GROUNDWATER SOURCE CONTROL INTERIM MEASURES DESIGN ANALYSIS, PLANS AND SPECIFICATIONS EAST HELENA FACILITY

Prepared for
ASARCO Incorporated
100 Smelter Road
East Helena, Montana

Prepared by:
Hydrometrics, Inc.
2727 Airport Road
Helena, MT 59601

**RESPONSE TO EPA COMMENTS
DATED FEBRUARY 16, 2000
ON SOURCE CONTROL
INTERIM MEASURES DESIGN ANALYSIS
DECEMBER 1999**

2-1

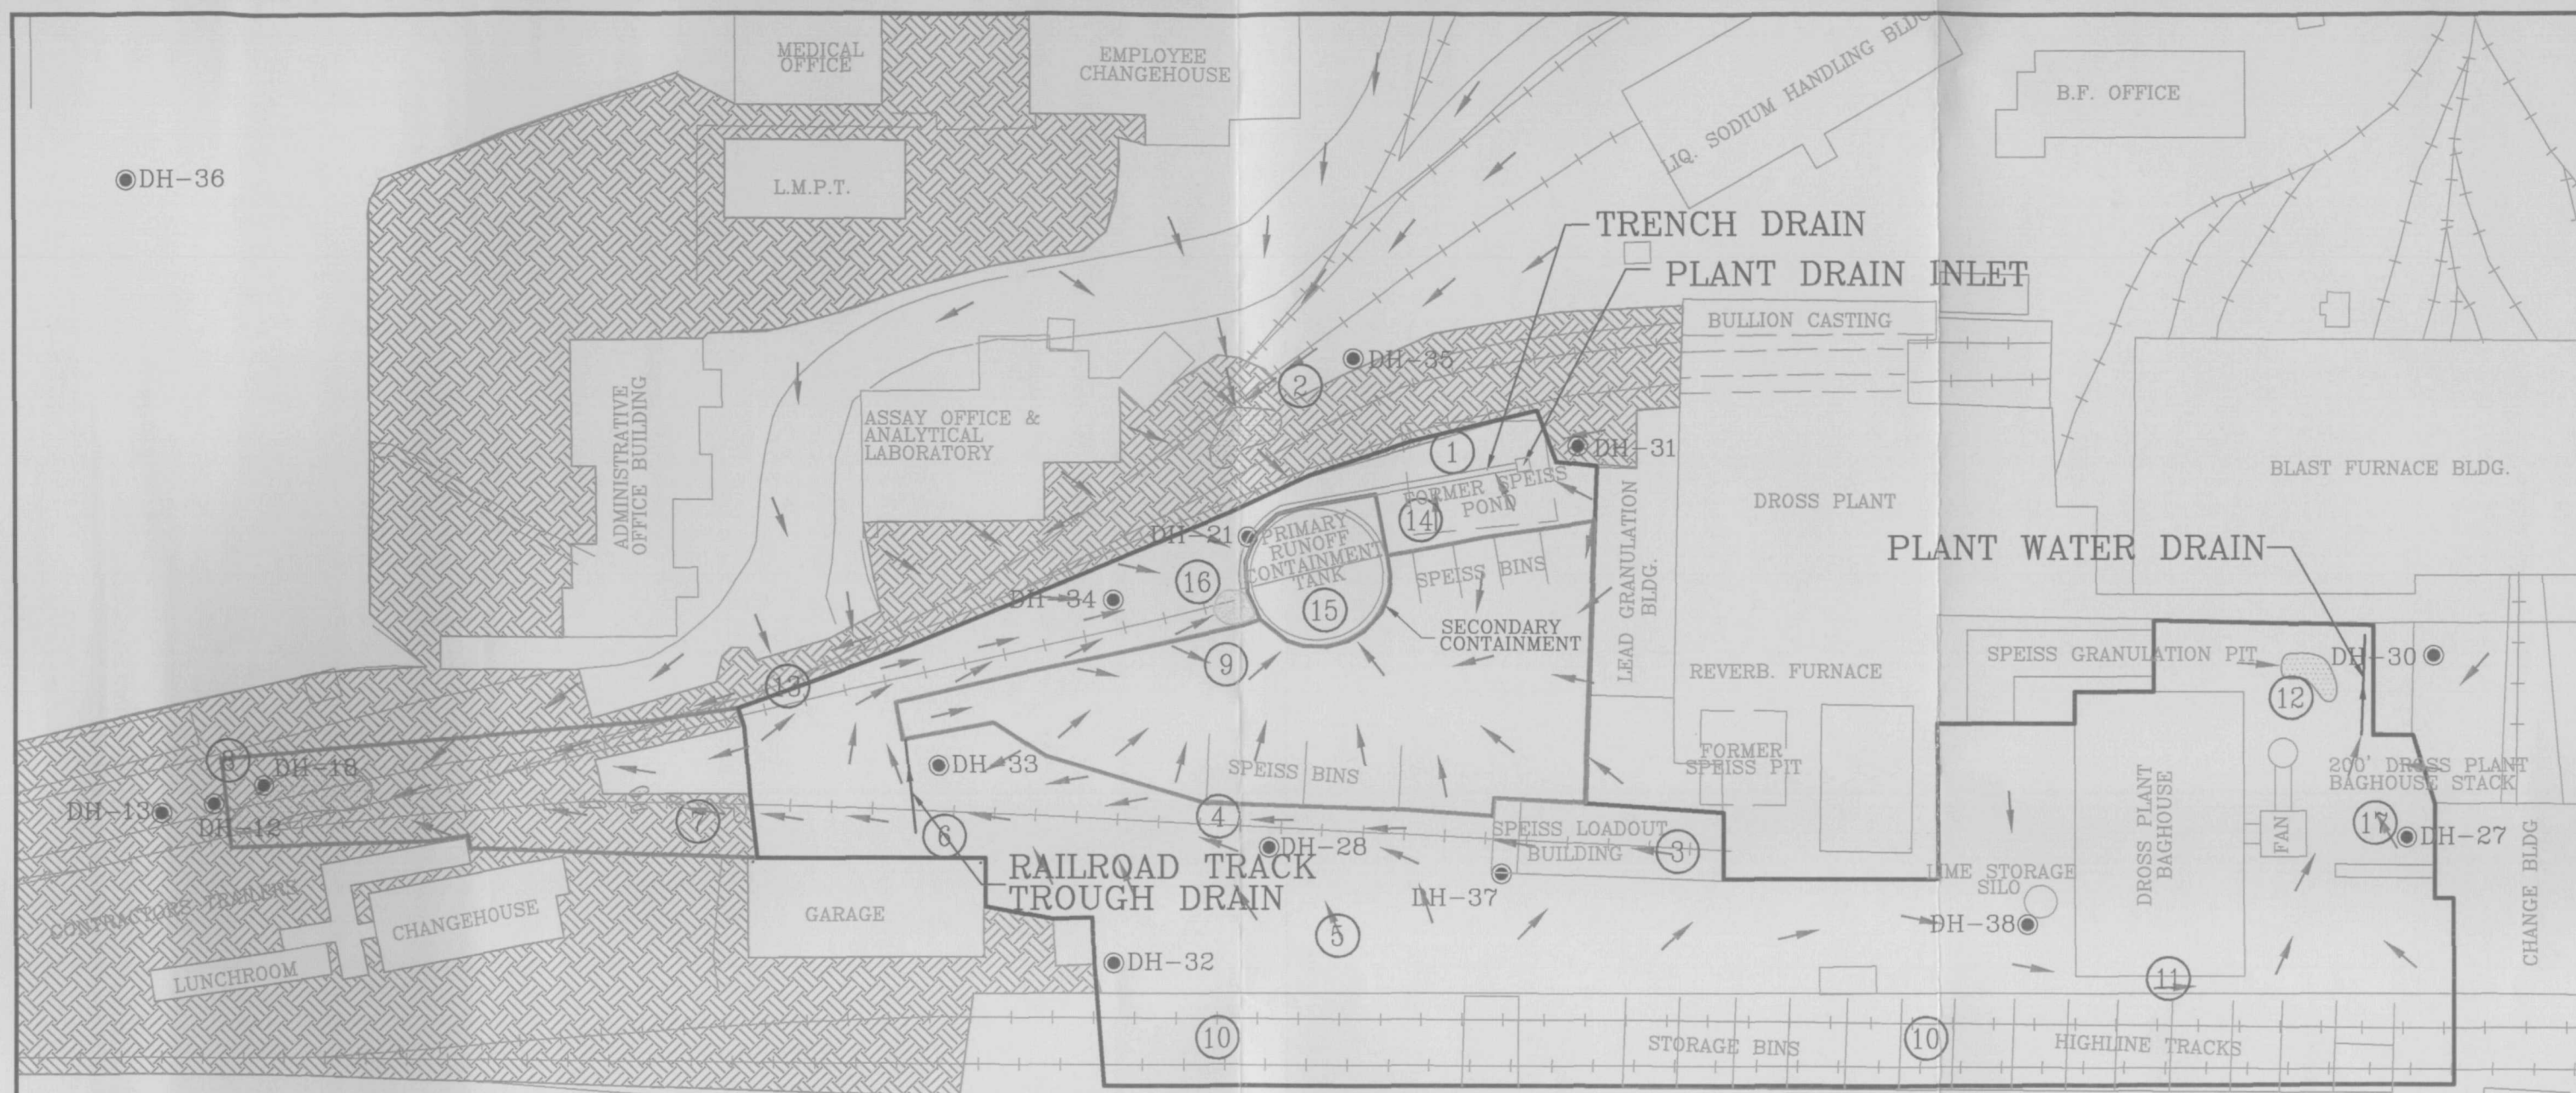
3. *To be clear about the limits of this report, Figure 2-1 of the IM Report should include the outline from Figure 4-1-2, IM Work Plan and mention should be made in the text that this was the predefined limit for mapping*

6. *Fig. 2-1: The photobase should be removed from the figure since it is of such poor quality. This figure covers nearly the same area as Figure 2-2. Provide a more legible base map, which incorporates Figure 2-1 legend information items into Figure 2-2.*

Add runoff arrows to the area immediately east of the plant drain inlet.

To the extent possible, identify boundary lines for common runoff areas. For instance, show how far east of the Contractor's Change House runoff flows toward the ponded area at deficiency 8.

7. *Fig. 2-2: Add the bins located at #10. At #9 in the legend, change "area" to "pad". The numbers contained in the legend should be identified as "Deficiencies". Add to the figure all areas where product-materials are routinely stockpiled. Identify the east-west dashed line at well DH-31.*

A dashed blue line should be added to indicate the estimated full extent that water ponds, or, if appropriate, change the description for the blue outline to "extent of ponding" in the legend.

- 11. Pg. 2-13, paragraph 1, last sentence: This pile of coarse sand does not appear to be identified on Figure 2-2. Did this sand appear to be a significant source of sediment in the trench drain? Was the sand placed as a means to control or treat stormwater?*

Response: As suggested in the comment, the facility area boundary has been added to a revised Figure 2-1. This revised figure incorporates the boundary outline as shown on Figure 4-1-2 of the IM Work Plan. It also combines information shown on existing Figures 2-1 and 2-2 to consolidate the information presented in these two figures and add clarity not present on existing Figure 2-1.

Response: As described in the response to General Comment 3 above, Figures 2-1 and 2-2 have been combined into one figure with a clearer base map.

The drain arrows shown on Figure 2-1 are representative of runoff in the plant drain inlet. Runoff from the unpaved area east of the inlet has not been observed.

The figures will be modified to specifically show runoff patterns associated with the Speiss Handling Area. It will not show runoff patterns in areas not affected by the handling of speiss. Only the area north of the railroad tracks are influenced from runoff from the Speiss Handling Area, and runoff at this location is primarily the result of the sediment filled track drain. The proposed plans to repair and replace this drain will eliminate the present runoff from the Speiss Handling Area to the area north and location #8.

Response: The requested modifications have been made to the figure. The east-west dashed line near DH-31 was a buried plant water pipeline and has now been removed from the figure, since it was an extraneous detail unrelated to surface runoff features.

Response: The sand pile has been added to Revised Figure 2-1. The sand pile was a source of sediment to the trench drain. The sand was placed at this location as a railroad car stop to prevent collision with the Speiss Handling Area runoff tank and containment system. Additional explanation has been added to the report.

**PRIMARY CONTAINMENT
LEAK TESTING**

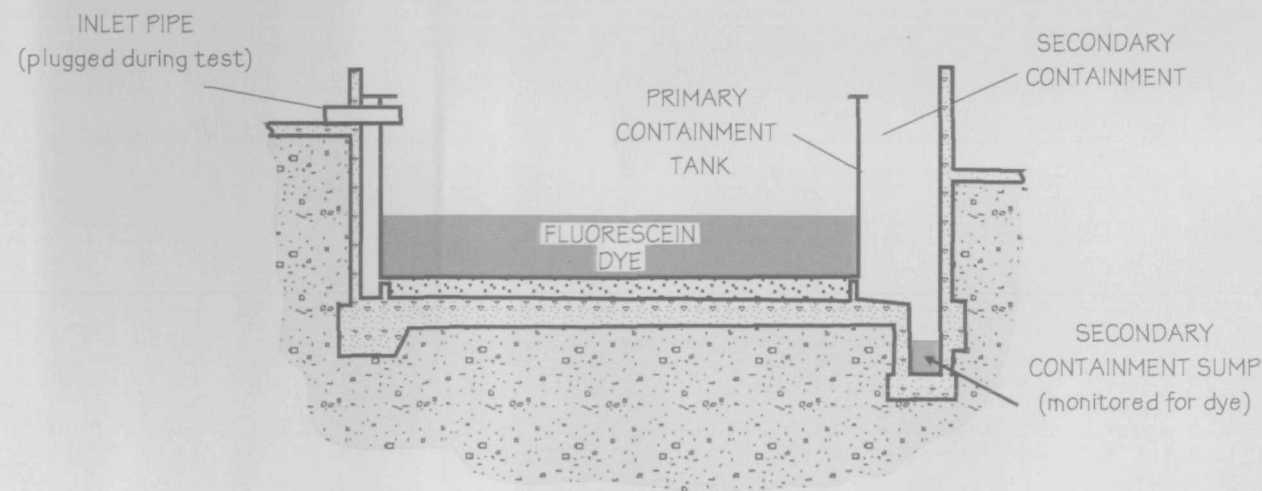
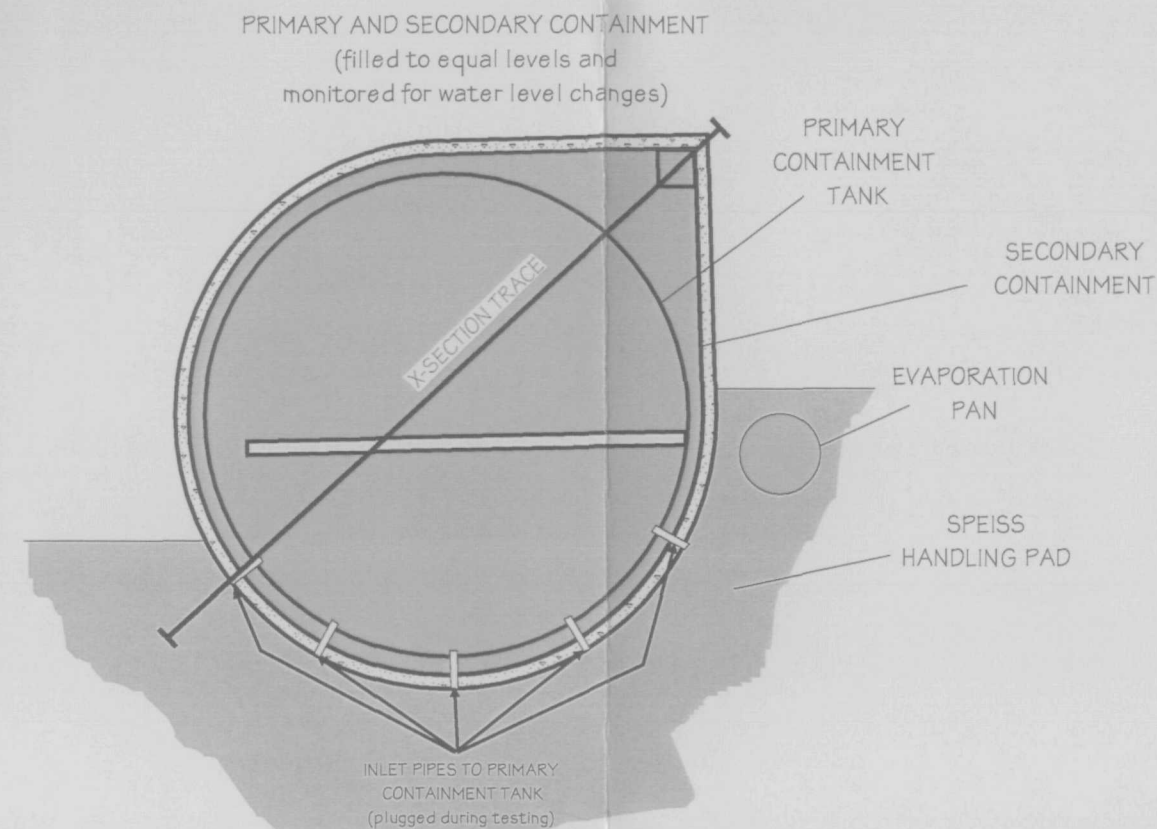
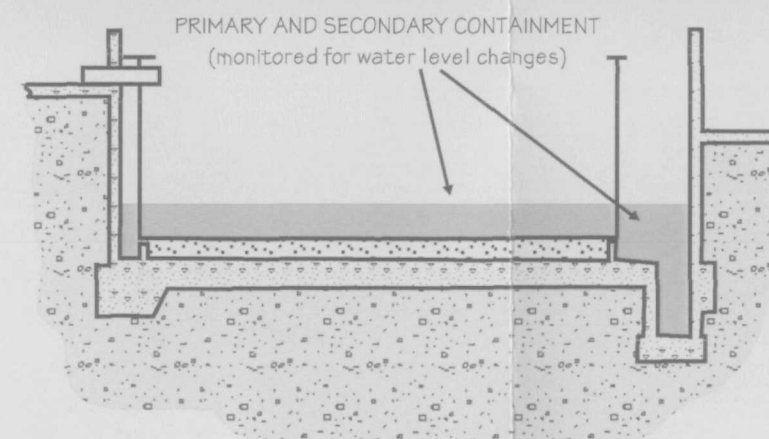
10. *Sec 2.2.2.2, paragraph 3: Provide a figure showing the test setup similar to that provided for secondary tank test. All level measurement data and fluid removal information for the sump should be provided. A statement, if true, that the sump of the secondary tank is constructed such that leakage from the primary tank would flow directly to it would help support the argument that leakage was not apparent. Each*

0.001 foot change in fluid level in the primary tank would equate to a fluid loss of 12 gallons. Would this leakage on a per day basis from a leak in the primary tank at any location be detected at the secondary tank sump? Explain why. Were any defects in the tank, such as cracks, observed?

Response: A figure has been added showing the set-up for both the primary and secondary containment testing. Detailed plans for the primary and secondary containment structures have also been added to the report. As indicated on the new figures, the sump in the secondary containment is designed to collect any seepage losses from the primary containment tank. It should be noted that seepage from the primary tank was not evaluated by recording water level changes in the secondary containment sump, consequently water level measurements for the sump are not provided on the figure. Instead a fluorescent dye was added to the primary tank, which provided a means of detecting even minor amounts of seepage to the secondary containment. As indicated in the report, no dye was detected in the secondary containment sump. Prior to testing, both the primary and secondary containment structures were drained and inspected for defects. No defects were observed in either of the containment structures

**FIGURE
3-1**

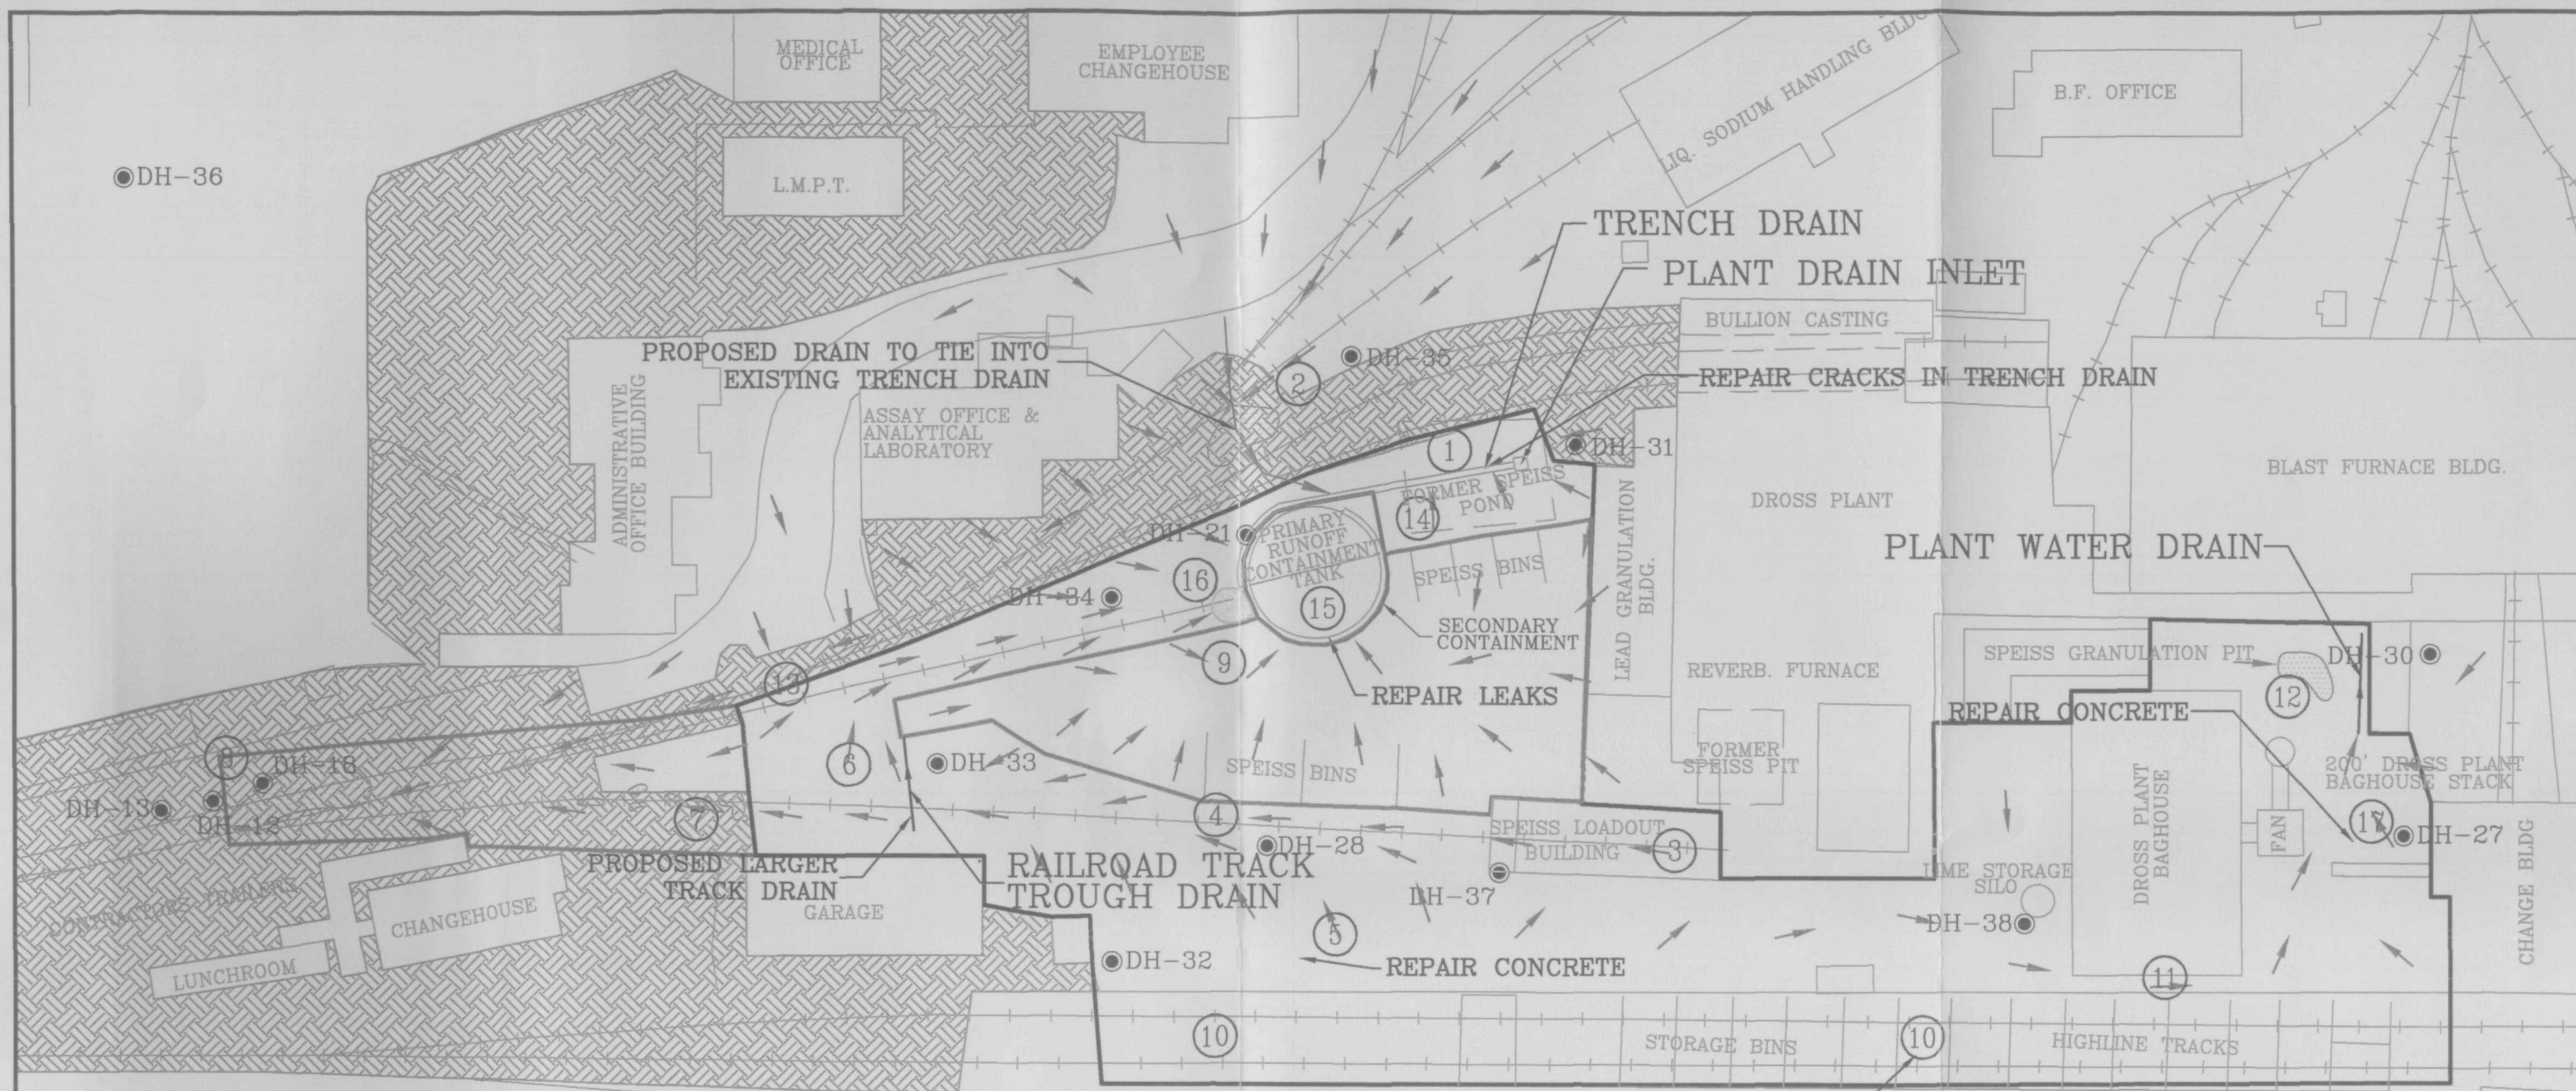
Key Item 6 - Photos 25 and 26 suggest that the concrete is beyond repair. As an alternative, a PVC liner, or similar material, could be laid over the area, or the concrete removed and a lift of fine-grained soil added so that evaporation in the soil profile may be used to reduce the amount of infiltration.

Response: The condition of the concrete in Photos 25 and 26 appears to be worse than it actually is. Patching and crack sealant application should be adequate to address infiltration over most of the Former Acid Plant sediment drying area. The primary concern, however, is eliminating ponding due to excessive run-on from water trucks. As noted in the comment other approaches to address the pad have also been added to Table 4-1.
